Village of Arlington Heights Building & Life Safety Department

Subject: 2525 N Arlington Heights Rd. – St Edna’s Church – PUD Amendment and Parking Variation, with Addition

PC#: 17-010

PLAN COMMISSION PC #17-010
St. Edna's New Parish Center Addition
2525 N. Arlington Heights Road
PUD Amendment, Parking Variation
Round 1

FIRE ENGINE TURNING TEMPLATE

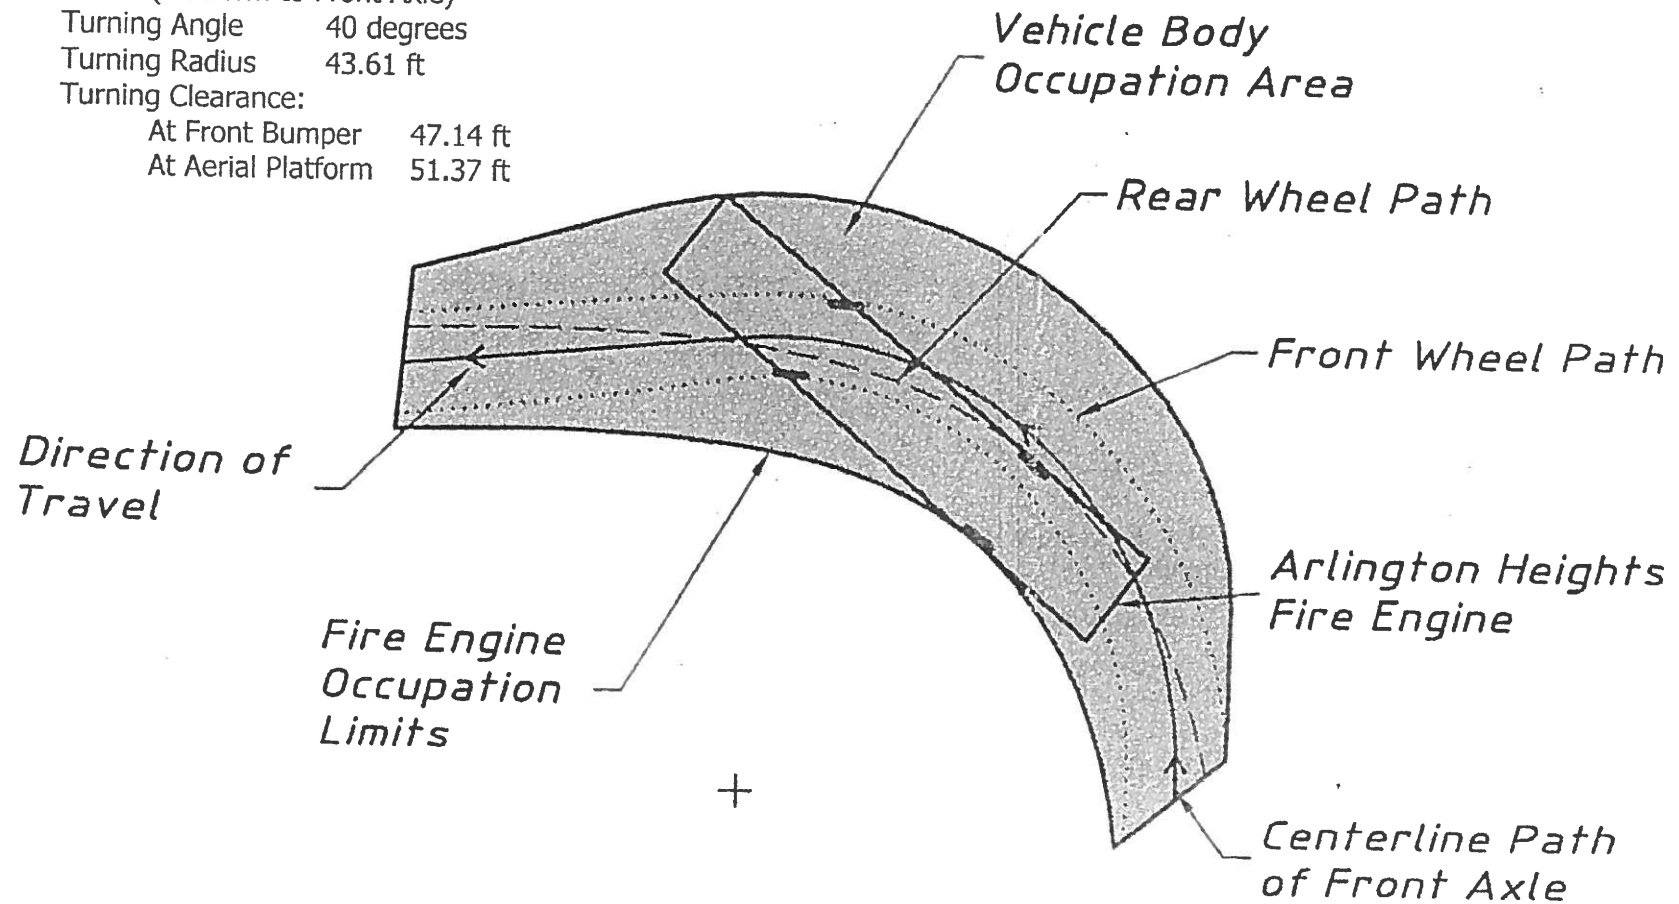
17. Provide an exhibit to engineering scale showing the turning path of the Fire Department's responding vehicle, in this case the tower truck. Exhibit must show front and rear wheel paths and the extent of the front and rear overhangs, as provided in an "Autoturn" exhibit. The vehicle shall be shown maneuvering through the site in all possible directions of travel. Attached are the specifications for the tower apparatus.
